Substantive response of the Local Highway Authority to a planning consultation received under The Development Management Order.

Planning Application Number: 25/00199/FUL

Application Address: Land Adjacent 232 Ashby Road Hinckley Leicestershire

Description of Application: Re-consultation. Erection of 25 dwellings, new access off Normandy Way, amenity space, parking and community orchard

Figure 1: Site Access.

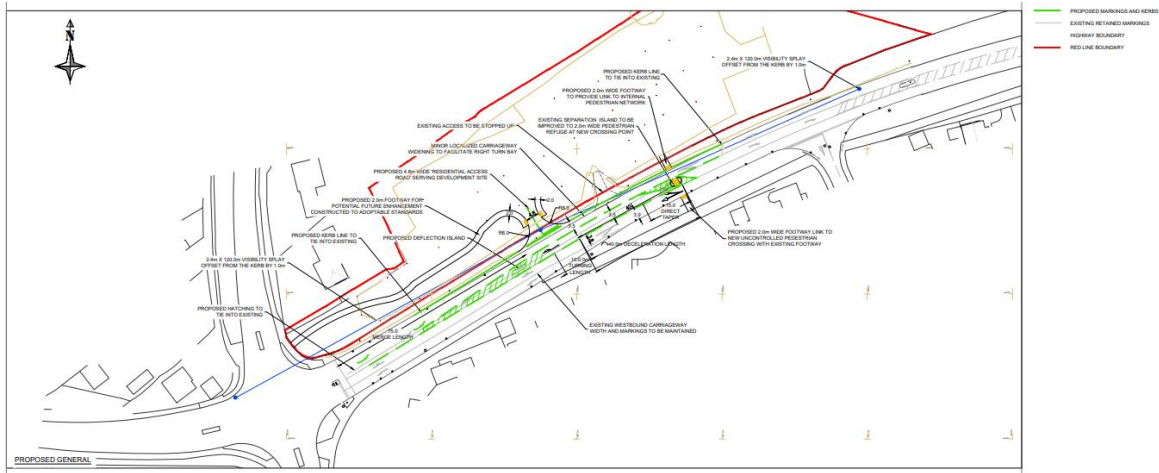
No further amendments have been made to the proposed site access since the last highway response, which is shown on MEC drawing number 29480_08_020_01 Rev. B and included in Figure 1 below:

The drawing of the site access arrangements continues to show a merge length of 75m for eastbound traffic exiting the A47 Normandy Way/ A447 Ashby Road/ B4667 Ashby Road signalised junction. As advised previously, Design Manual for Roads and Bridges (DMRB) CD123, Para. 7.12.1 states that where it is necessary to reduce the number of lanes on the exit arm, a single lane should be reduced over a distance of 100 metres starting at or beyond the limit of the junction intervisibility zone. The Applicant has responded within point 2 of the TN emphasising the following points:

Whilst acknowledging some of the points raised above the LHA would advise the Applicant that the principal concern in respect of the proposals is the reduction of the length of the exit arm to below the 100m length advised in the DMRB to provide the ghost right turn lane into the site. The LHA advise that capacity/ congestion and safety concerns are well known at the junction and whilst it is accepted the DMRB advice specifically on this point is guidance only, under the site-specific circumstances, the LHA believe reducing the exit arm merger to below the recommended 100m would not be beneficial and could discourage use of the right hand lane through the junction. The LHA therefore consider the Applicant has failed to demonstrate the site access would be in a safe and suitable location, given the reduction in the merger lane and the volume of traffic using Normandy Way (A47).

Given the existing junction capacity and highway safety concerns, LCC would not consider it appropriate or in the interest of highway safety to seek to reduce the length of the merging lane as part of the proposals as they are currently to DMRB recommended standards.

The LHA remain concerned that reducing the merging lane to below the recommended standards and the provision of an additional right turn lane on Normandy Way (A47) in this location could severely restrict the design for the eastern arm of the junction and the effectiveness of the highway improvement scheme on increasing capacity, reducing congestion and improving highway safety. Thus, the LHA consider the proposals, if permitted, would be contrary to Policy 2 of the LHDG.

Regrettably, the LHA cannot see any reasonable way to resolve this concern with access off Normandy Way (A47), as the site access could not be relocated further west towards the signalled

junction and to relocate it further east would impact on the existing ghost right turn lane for the Cornwall Way estate.

- The reduction in the merger to 75m would not generate an unacceptable impact in highway safety terms given DMRB CD123 Para. 7.12.1 is guidance rather than mandatory and that 75m would still enable 13 vehicles to merge at the end of the junction intervisibility zone.

- Provision of a right turn lane would enhance road safety given existing site users currently block ahead movements whilst waiting to turn into the site.

- A right turn lane would not interfere with the committed improvements for application reference 22/00318/OUT given its proposals are exclusively contained on the northern, southern and western sides of the junction.

- After reviewing the modelling undertaken as part of application 22/00318/OUT the eastbound exit arm was modelled with an 'infinite saturation flow'. Therefore the reduction of 25m in the exit merge length would have no capacity impacts given the modelling already accepted as part of that application.
